**ITEM 9. DEVELOPMENT APPLICATION: 863-871 BOURKE STREET
WATERLOO - VALIANT HIRE SITE**

FILE NO: D/2006/1387

Figure 10: Proposed Bourke Street elevation

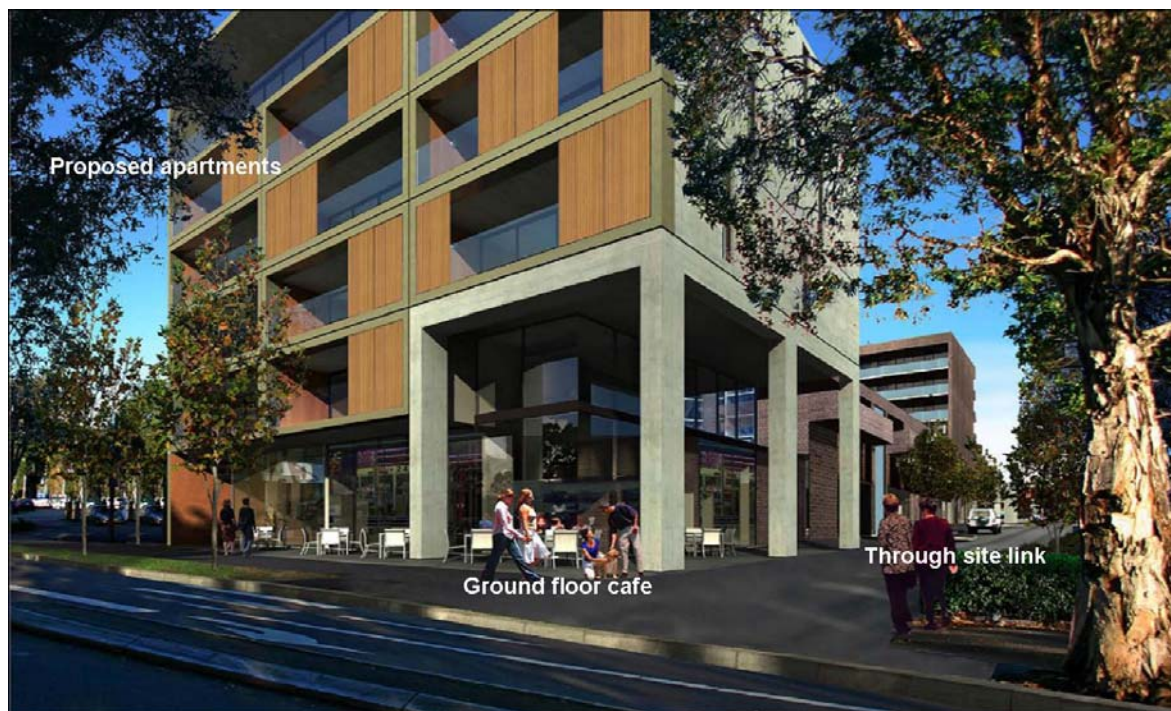
- (c) modification of the Bourke Street elevation by the introduction of visual relief so that the apparent maximum horizontal dimension of street walls to Bourke Street is no more than 40 metres;

The proposed main building acts to reinforce the strong street edge set by the neighbouring development in Bourke Street. The facade of the main building is acceptable in principle but it is considered that the design of the street wall on Bourke Street (over 75m in length) may be modified further to reduce its apparent length. Such design amendments may include the introduction of a recess between the linear six storey street wall and the tower component.

42. The Panel raised concerns over the length and articulation of the Bourke Street facade of the main building. The Panel recommended that recesses or some other design solution be implemented to break up the apparent length of the facade, and that the materials selection and fenestration be revised.

Figure 14: Contextual analysis showing the height of neighbouring buildings. The "4*" indicates a 4 storey commercial building, equivalent to 5 residential storeys.

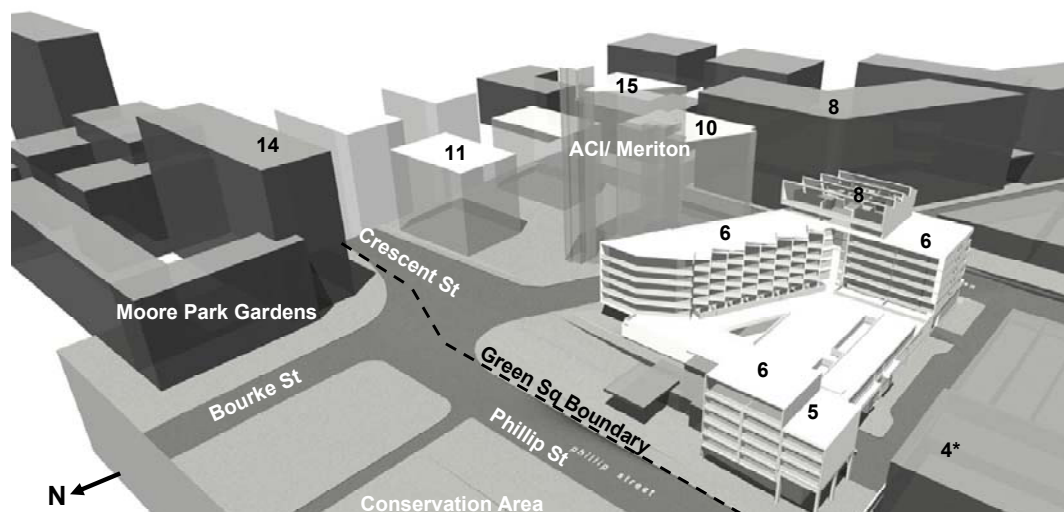
48. It is considered that the relationship between the part 5, part 6 storey Phillip Street building and the single storey dwellings on the opposite side would be improved with a reduction of the 6 storey element to 5 storeys (an equivalent street wall height to the existing residential apartment building to the west at 189 Phillip Street). It is noted that this adjacent apartment building is a commercial building conversion, and although only containing four storeys (albeit with 'commercial' ceiling heights), is equivalent of a five storey residential scale.
49. This reduction in scale of the Phillip Street building should also be addressed by the applicant prior to the CEO determining the DA.

Figure 15: The proposed scheme of public domain improvements.

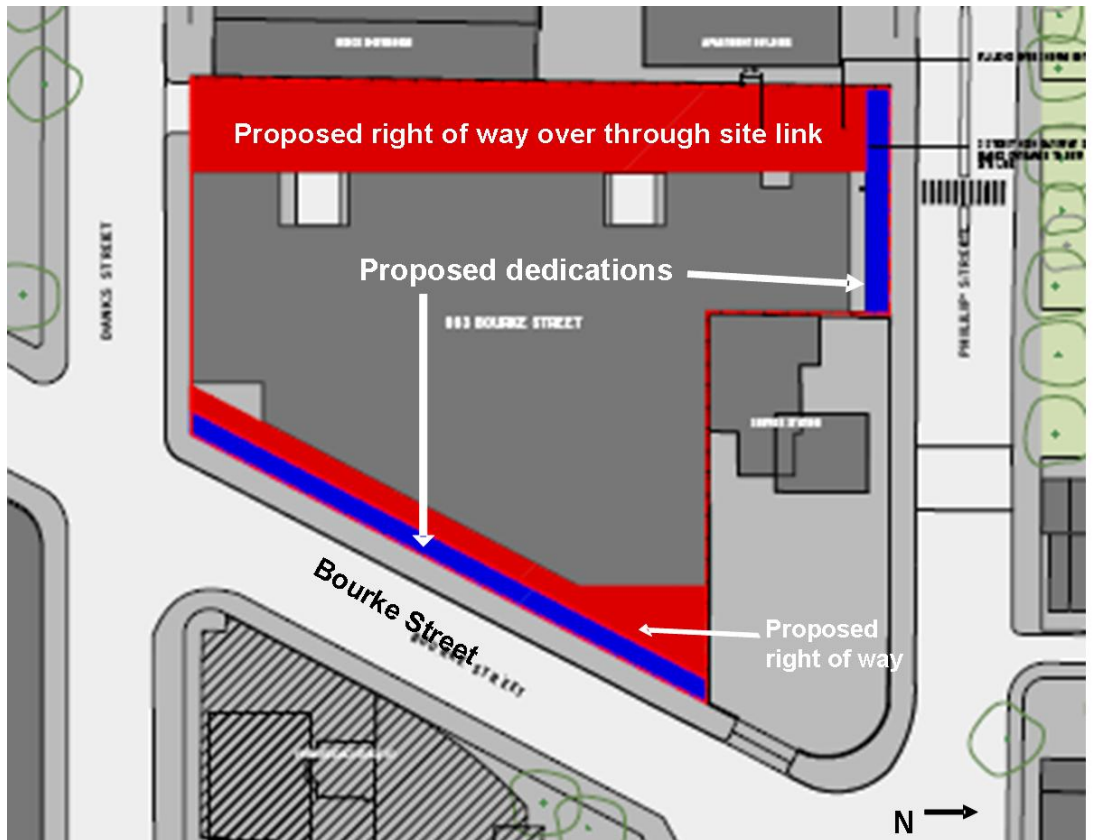
58. At this point in time, only two aspects of the proposed package are acceptable – the Bourke Street 3m setback and dedication, and the right of way over the “pedestrian part” only of the through site link. There is little material public benefit in rights of way over the Bourke Street shopfront area or the driveway of the development, and the small nook of land offered to be dedicated on Phillip Street has little utility as a public asset.

59. Given the above comments and that the overall size of the development will be reduced (refer earlier urban design and height comments), a revised public benefit offer will be required. This revised offer will need to ‘match’ the reduced development and be formalised into a Voluntary Planning Agreement. It is noted that formalisation of the Agreement includes public exhibition of the draft Agreement and consideration of any public submissions received.
